Site Plan Review For Ypsilanti Township, Michigan

Applicant:	Crown Enterprises
Project Name:	Hercules Concrete Plant
Plan Date:	August 3, 2021
Location:	2555 State Street, Ypsilanti Twp
PID:	K-11-13-256-002
Zoning:	I-C, Industrial and Commercial Districts
Action Requested:	Final Site Plan Review.
Required Information:	As noted in this report.

RE: Hercules Concrete Plant 2555 State Street Site Plan Review #1

> Re: Preliminary (non-residential) Site Plan Review #1 Hercules Concrete Plant Charter Township of Ypsilanti (Plan Date: 08-03-2021)

SHEET TITLE			
SHEET NUMBER ISSUE			
CU-101

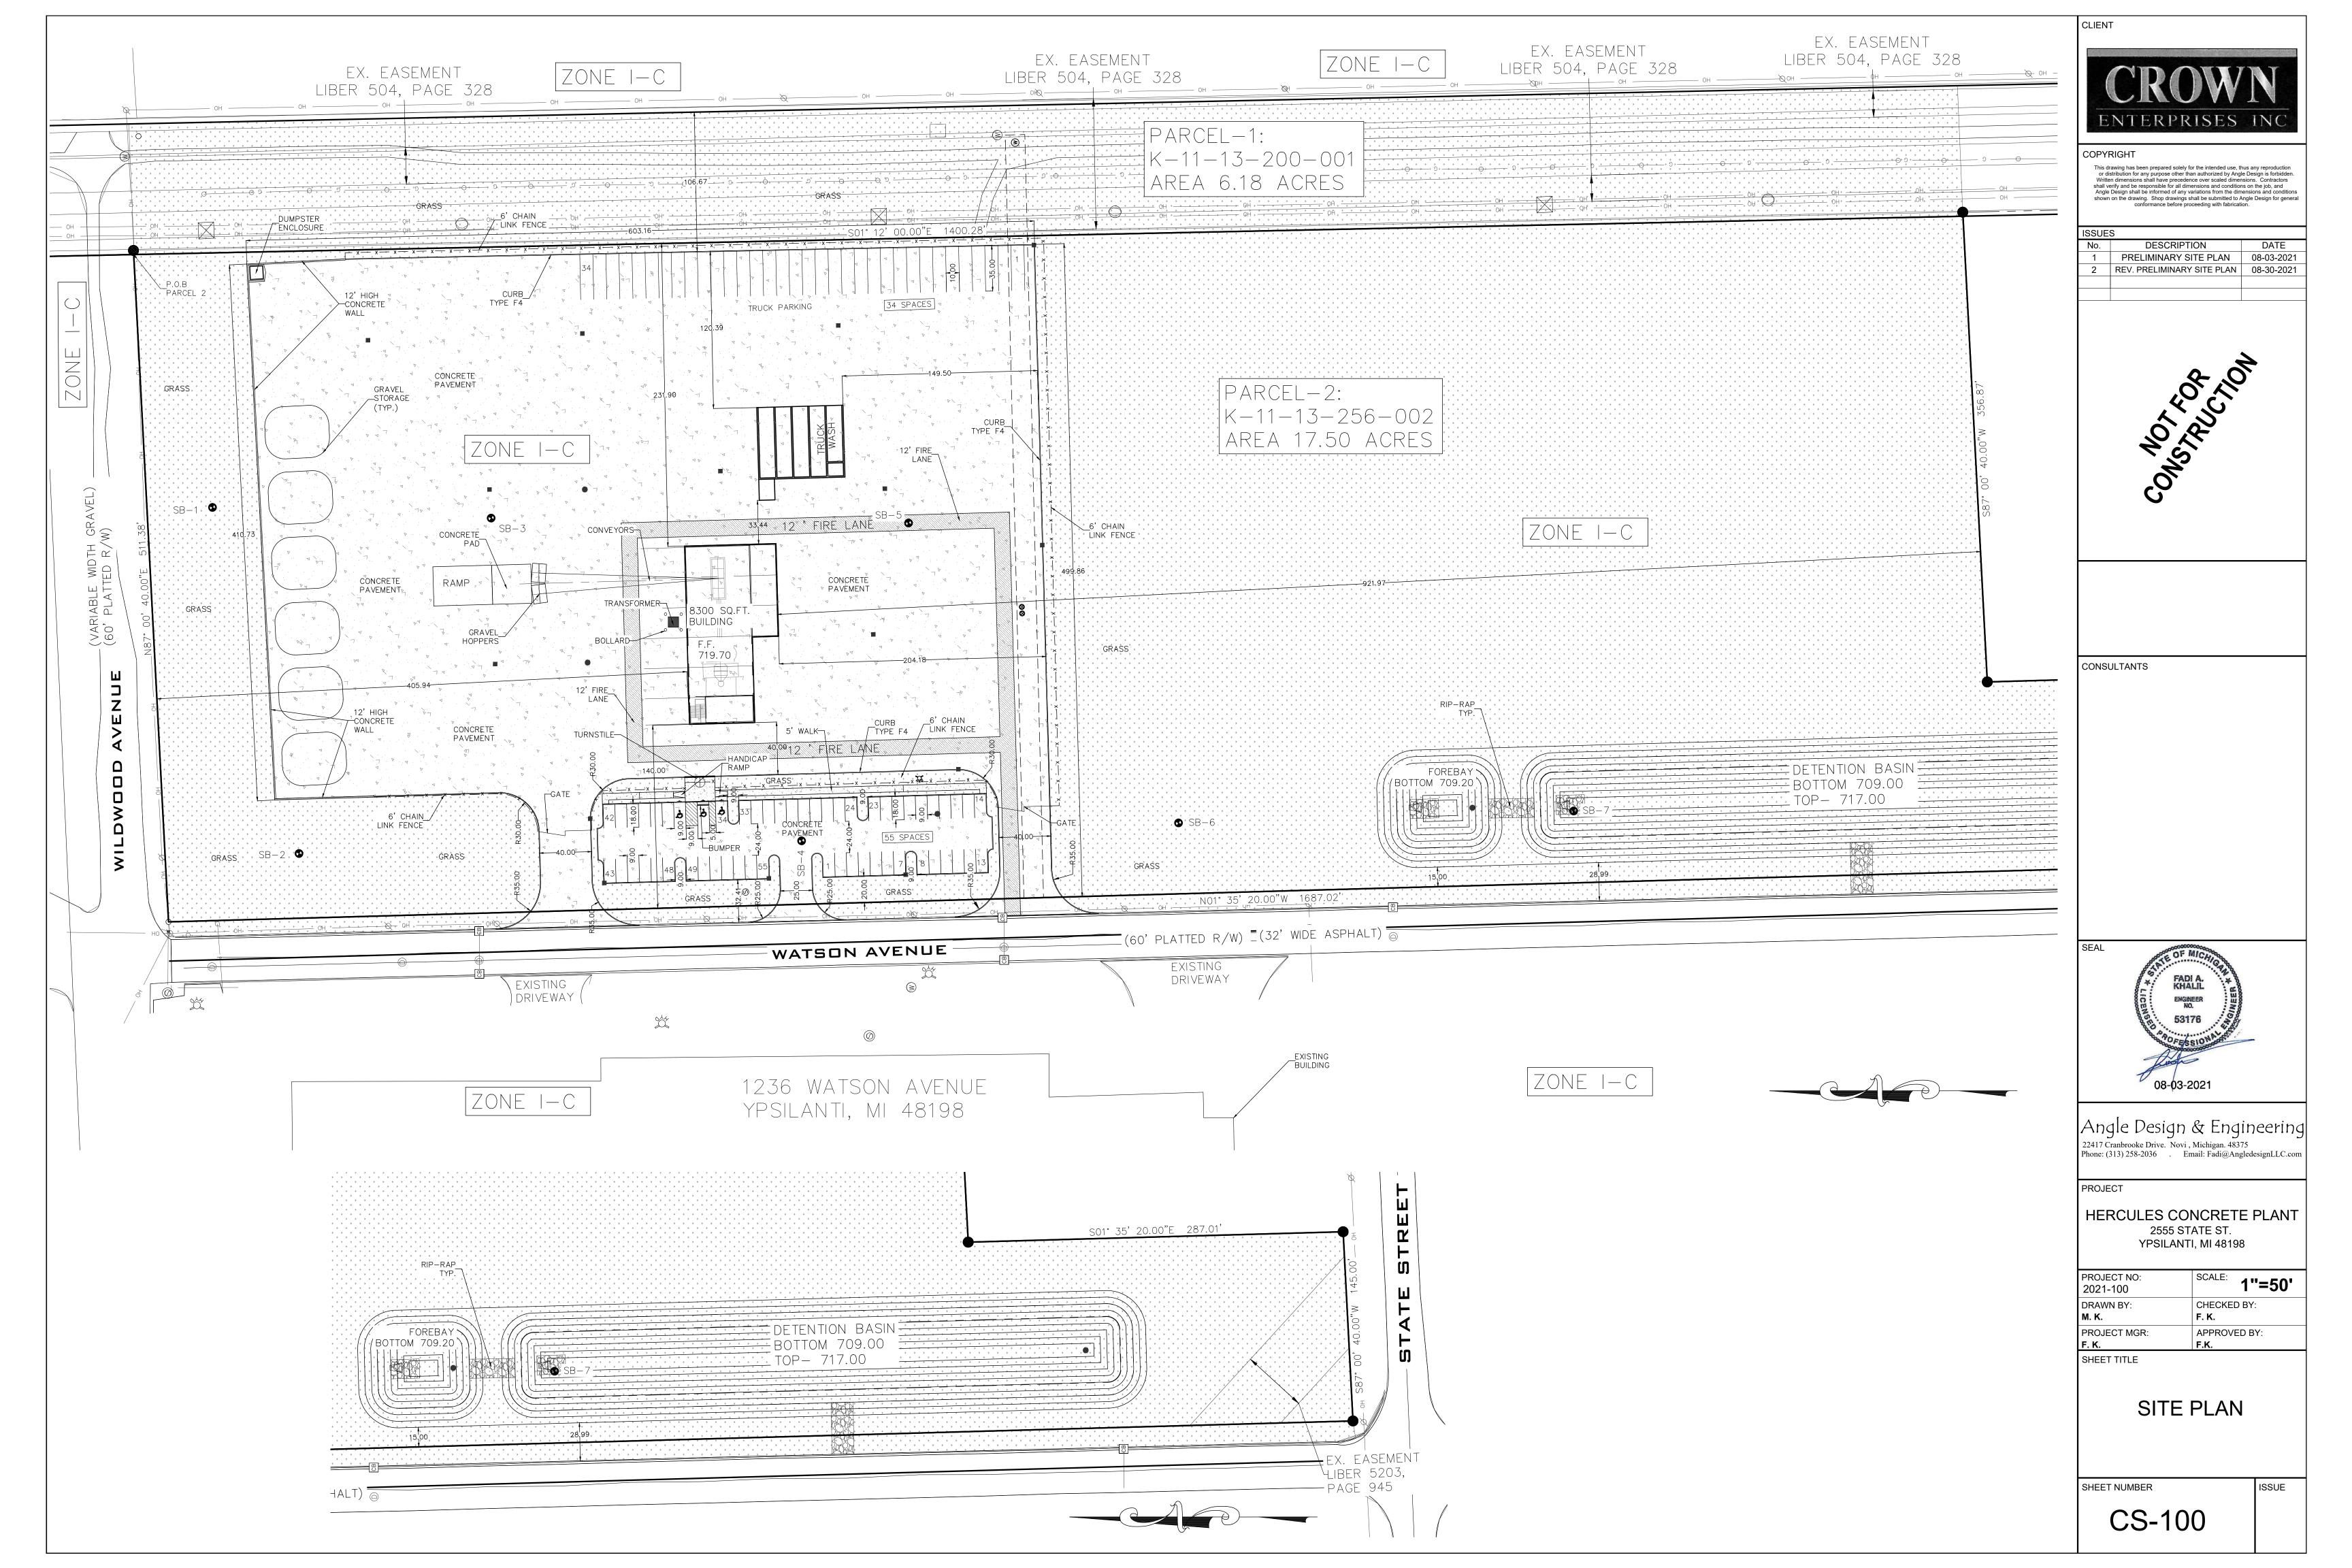
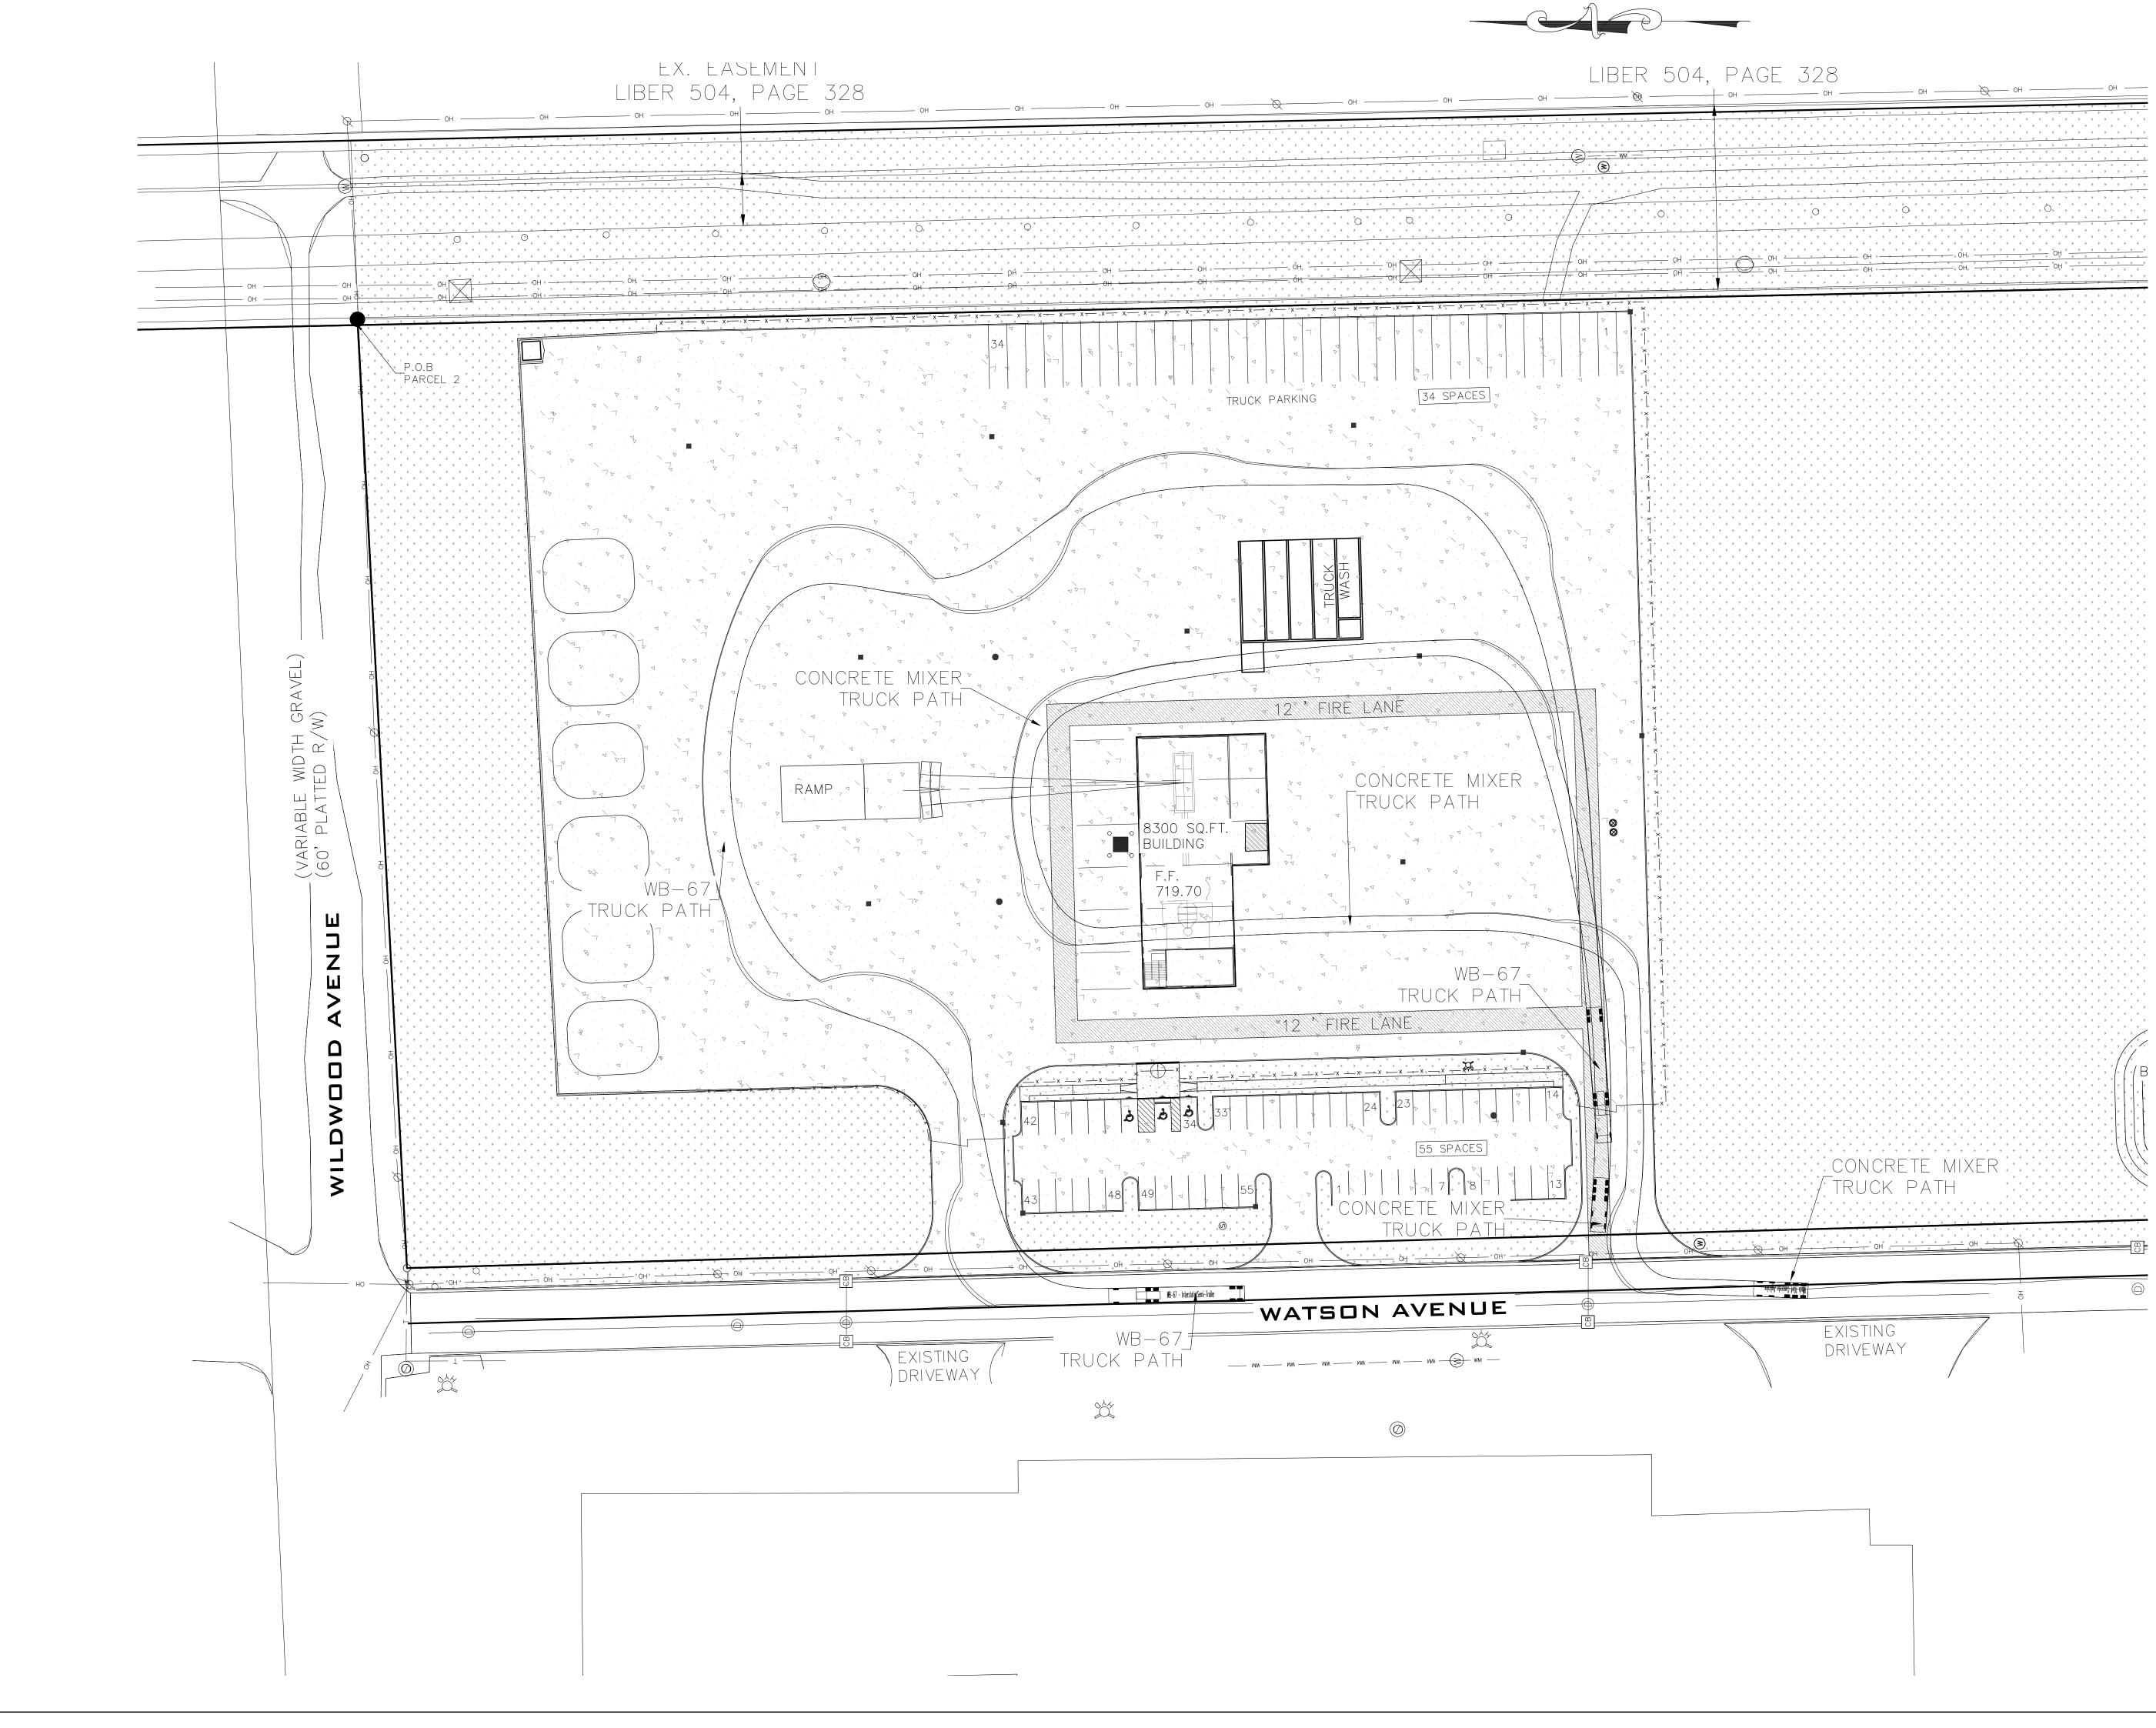
1. It currently appears that the proposed sanitary sewer locations on the utility plan sheet and the landscaping sheet differ. The applicant shall ensure there is no direct conflict between proposed trees and the proposed underground infrastructure and revise accordingly.

- 1. The proposed water main alignment is unacceptable. A marked-up copy of the proposed utility plan sheet showing an acceptable alignment is enclosed. In particular, an existing gate valve just north of the end of the existing 8" diameter water main on Watson Avenue eliminates the need for a tapping sleeve and valve and the connection to the existing 24" diameter water main parallel to the east property line needs to be made south of the existing gate valve.

- 2. The utility plan shows both a 2" diameter water service and a 4" diameter water service to the proposed building. It is unclear why two separate water services are necessary.

- 3. The upstream terminus of the existing sanitary sewer on Watson Avenue is located just northwest of the existing 8" diameter gate valve noted it item 1 above. This manhole may provide a more cost effective connection location for the wastewater discharge from the proposed facility.
